## 5 SUBMISSION RESPONSES – VOLUME C

### 5.1 C1 – Alternative Locations to Middle Banks for Sand Dredging and Proposed Dredge Methodology (4 of 196 submissions)

## 5.2 C1 – Dredge Footprint Plan

Figure 1.6a/ Figure 9.2a: Revised Dredge Footprint Plan

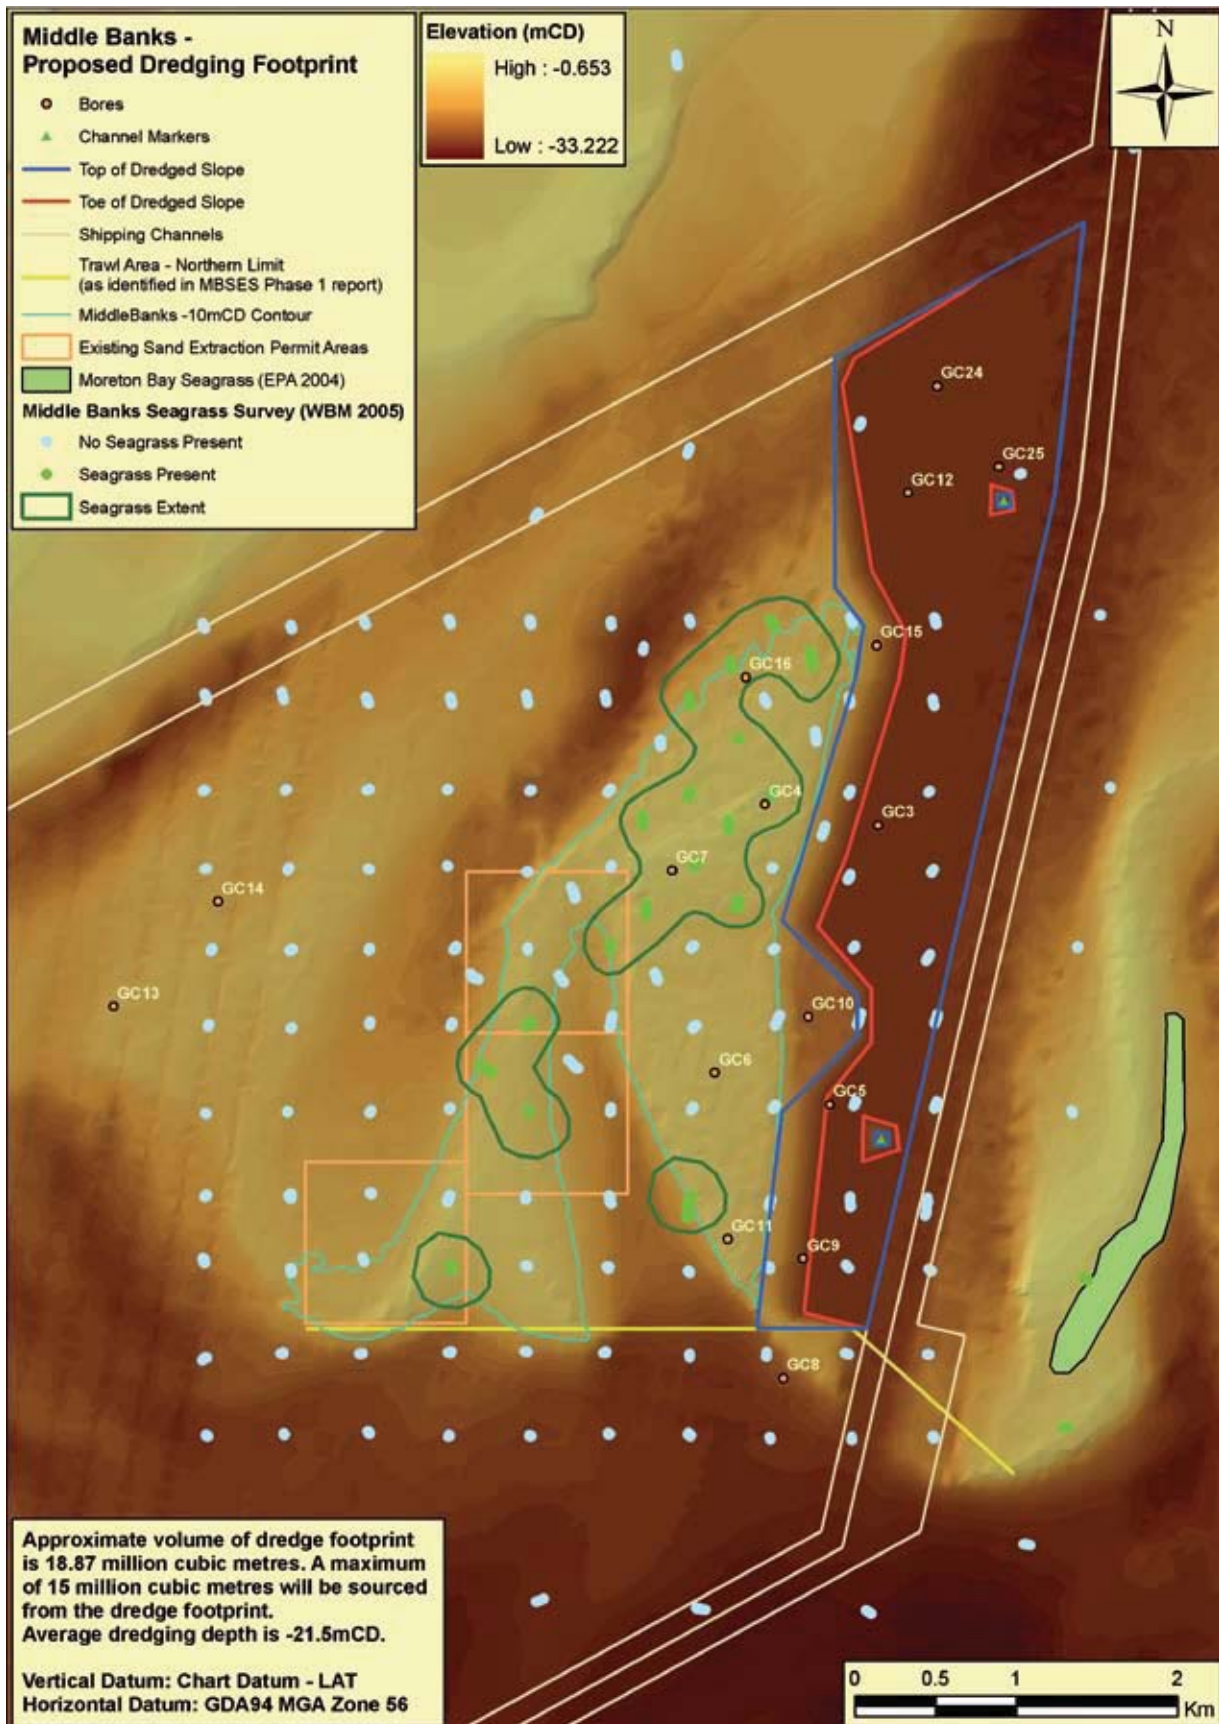
Several submitters made comments about the dredge footprint plan as shown in the Draft EIS/MDP in Figures 1.6a and Figure 9.2a as referenced above.

- Confirmation that Chart Datum was equivalent to Lowest Astronomical Tide (1/2).
- That sampling data of seagrass along the Moreton Island foreshore undertaken in 2004 as part of the Ecosystem Health Monitoring Programme be shown on the plan (1/2).
- Observation that not all of the points shown in the seagrass sampling at Middle Banks by WBM (2005) as shown in Chapter C5, Figure 5.5b are reflected in the dredge footprint plan on Figures 1.6 and Figure 9.2a (1/2).

The dredge footprint plan has been amended to clarify that Chart Datum is Lowest Astronomical Tide (LAT).

The 2004 seagrass mapping mentioned in the submission has been obtained and added to the dredge footprint plan.

The additional seagrass points from Figure 5.5b have been added to the dredge footprint plan. This was a mapping error that occurred when the data was imported and does not change the assessment outcomes or key findings of any part of the Draft EIS/MDP.

A revised dredge footprint plan incorporating the submitter issues raised above is shown below.

For the Draft EIS/MDP, the Figure below replaces Chapter C1, Figure 1.6a, and Chapter C9, Figure 9.2a.
